GREAT FALLS HIGH SCHOOL

CONCERNS ABOUT THE HISTORIC CONTEXT OF THE GFPS DISTRICT DESIGN PROPOSAL

BY DARRELL SWANSON AIA 06/13/18 406.599.6910

GFHS DESIGN SUBMITTAL / MAY 14, 2018

GREAT FALLS HIGH SCHOOL / UPDATED CAMPUS SITE PLAN

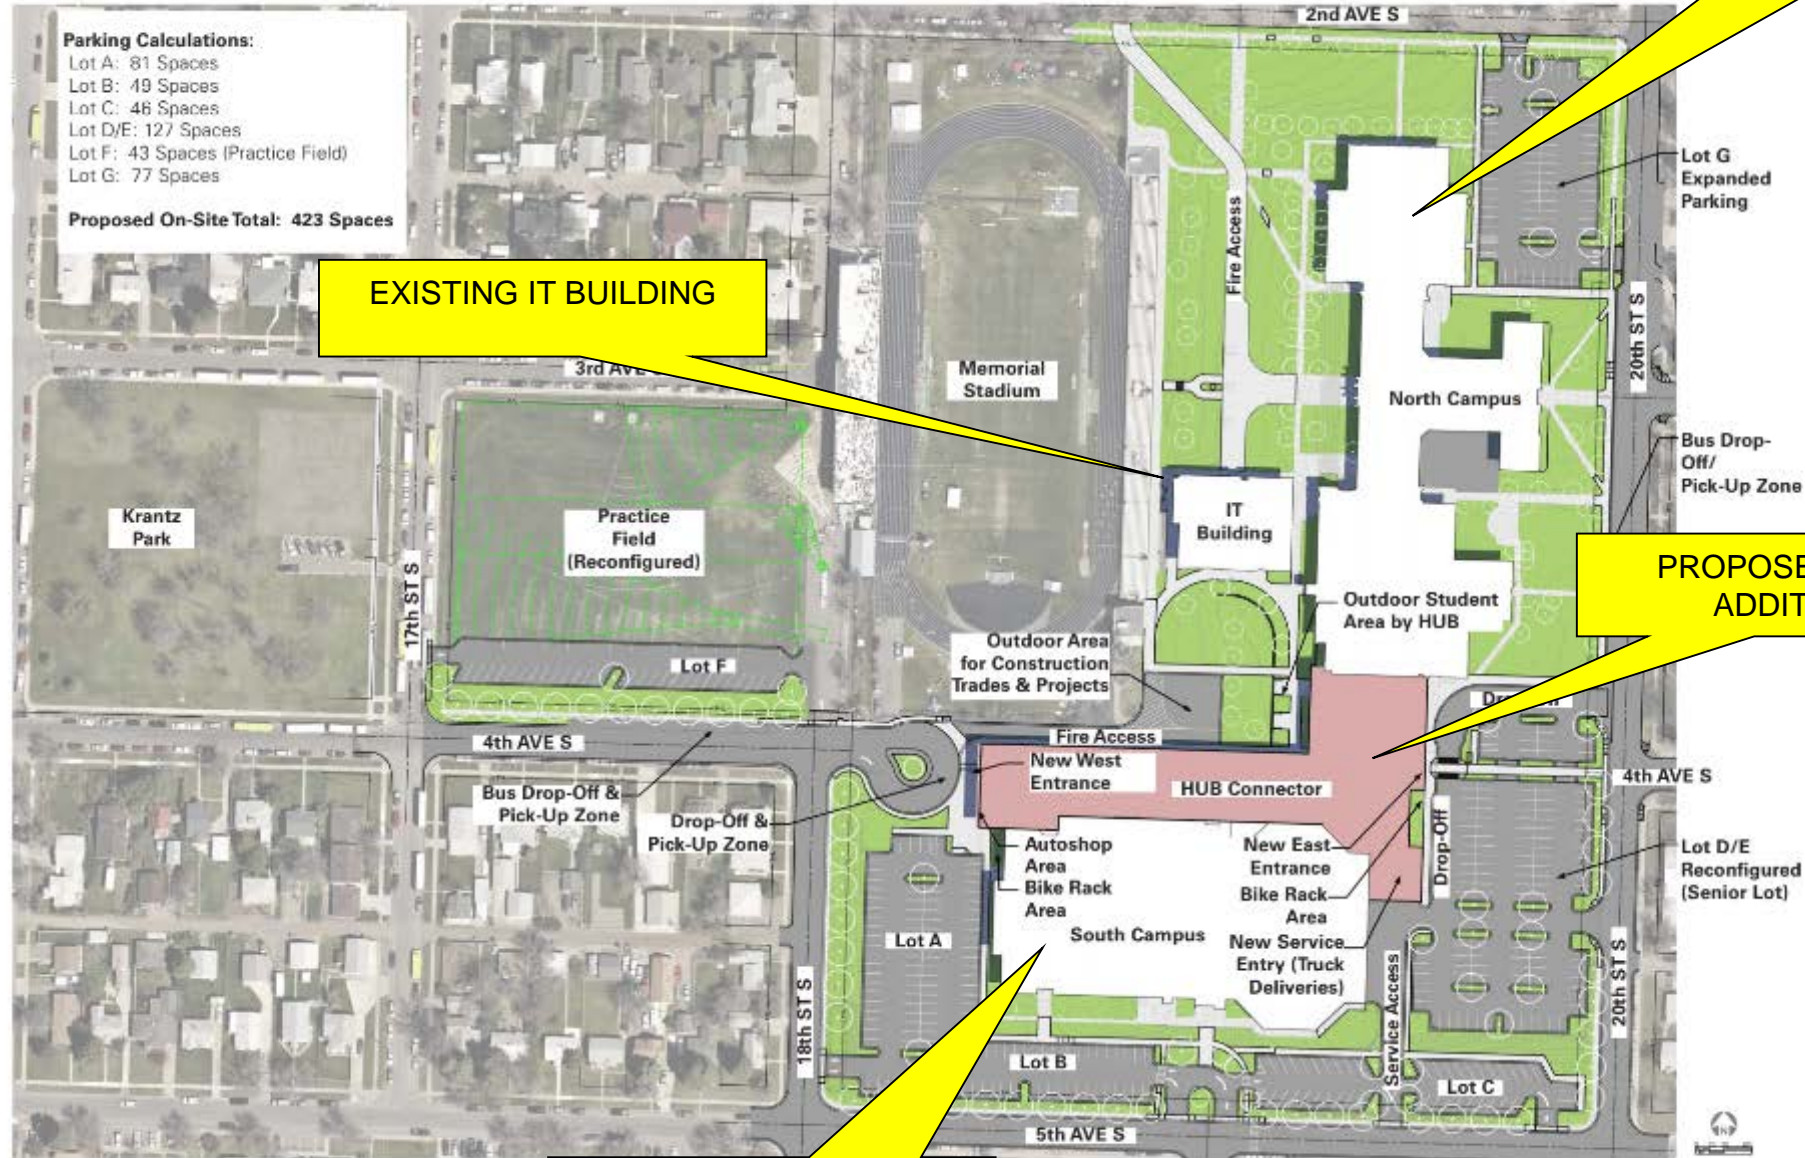
REMOVES MATURE TREES AND LANDSCAPING FROM HISTORIC CAMPUS TO BUILD ASPHALT PARKING LOT

ADDS FIRE TRUCK LANE TO THE MIDDLE OF ORIGINAL HISTORIC CAMPUS FLAG COURT AND PLAZA.

RETAINS THE EXISTING IT BUILDING THAT RESTRICTS ACCESS TO THE ORIGINAL HISTORIC CAMPUS FLAG COURT AND PLAZA.

CONCEALS SOUTH SIDE OF HISTORIC BUILDING WITH TWO STORY HIGH ADDITION

REMOVES PART OF PRACTICE FIELD TO BUILD NEW PARKING LOT

CLOSES THE HISTORICAL EAST/WEST PEDESTRIAN AXIS THROUGH THE CAMPUS, THEREBY FORCING PEDESTRIANS ON LONG TIME CONSUMING AND UNEVENTFUL VOYAGES AROUND THE PERIMETER OF THE CAMPUS

REMOVES MATURE TREES, LANDSCAPING, AND HISTORIC ORNAMENTAL FENCE TO BUILD ASPHALT PARKING LOT

FILLS UP THE HISTORIC HEART OF THE HISTORIC CAMPUS WITH SURFACE PARKING LOTS AND STRUCTURES
